US Route 2
Cabot-Danville, VT
7' x 7' Box Culvert - Culvert Sections

**US Route 2
Cabot-Danville, VT
7' x 7' Box Culvert - Cutoff wall**

DESIGNED BY: DTM				PROJECT NAME	U.S. ROUTE 2 OVER EXISTING STREAM	DATE 04/8/11
PROJECT ENGR: LY	2	8/19/11	REV. PER GIA COMMENTS REV. HALF CONNECTOR DETAILS	LOCATION	CABOT-DANVILLE VERMONT	CONTRACT NO. RE-15053
CHECKED BY: PLA/EEH	1	7/19/11	REV. PER GIA COMMENTS	OWNER	VTAOT	DRAWING NO. 1 OF 7
REV.	DATE		DESCRIPTION	DRAWING COVERS	GENERAL NOTES	SCALE AS SHOWN

HIGHWAY SAFETY CORP GLASTONBURY, CT 860-633-9445	
ITEM 525.33 BRIDGE RAILING -- NETC 2 RAIL US RT 2 OVER EXISTING STREAM TOWN OF CABOT-DANVILLE, VERMONT PROJECT NUMBER: F EGC F 028-3(26)C/1	
GENERAL CONTRACTOR SUB CONTRACTOR F.R. LAFAYETTE, INC.	CERTIFIED FABRICATOR FISC. ACB NO. 1807 SHEET NO. 1 of 3
DRAWN: MMH DESIGNED: PAR DATE: 3-25-11 SCALE: N.T.S. SIZE: D

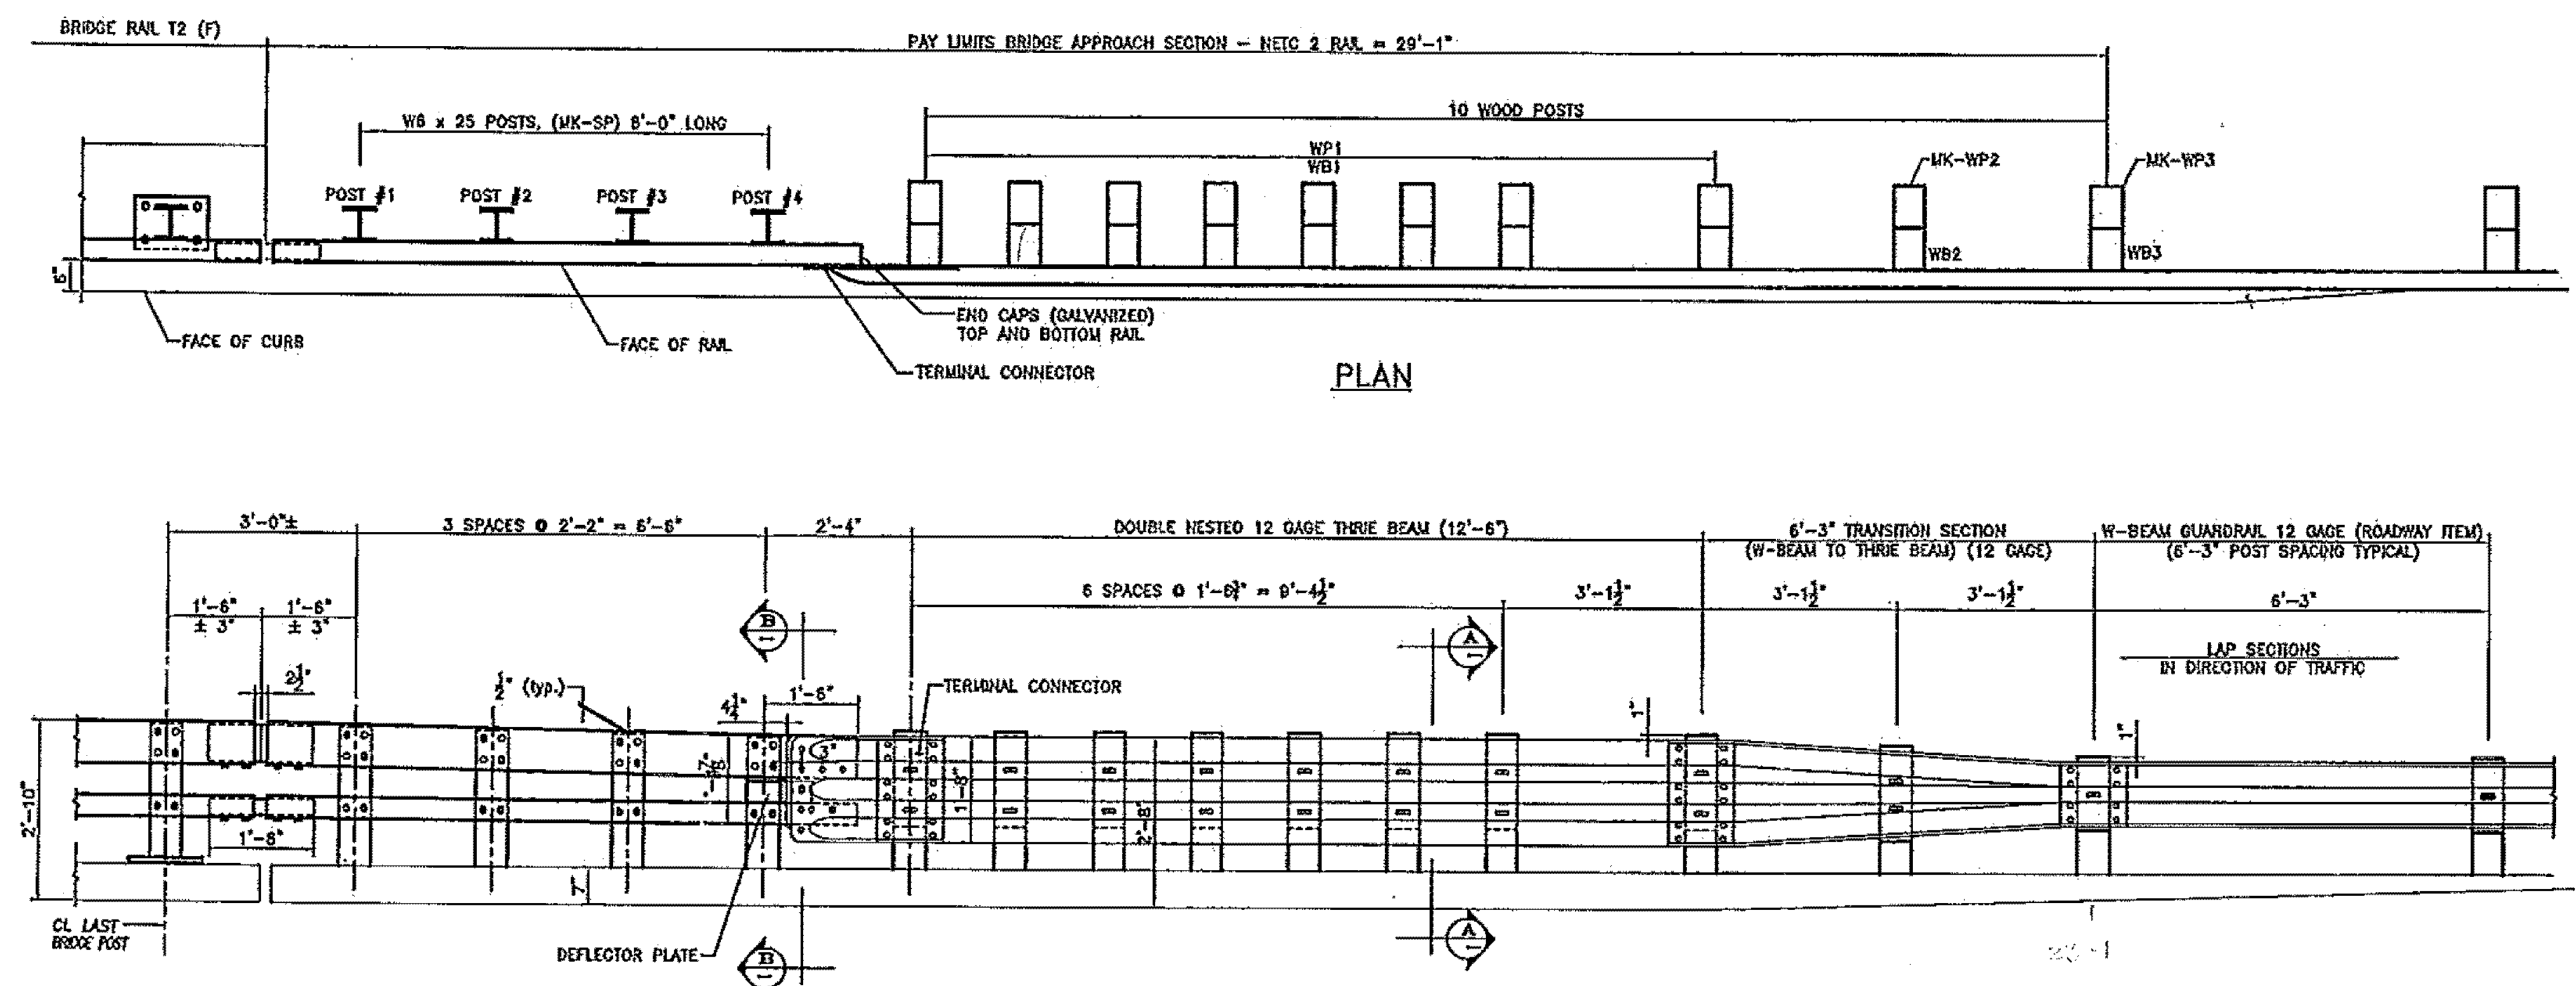
REVISE WITH INITIAL TYPE
(REF. SHT 2)
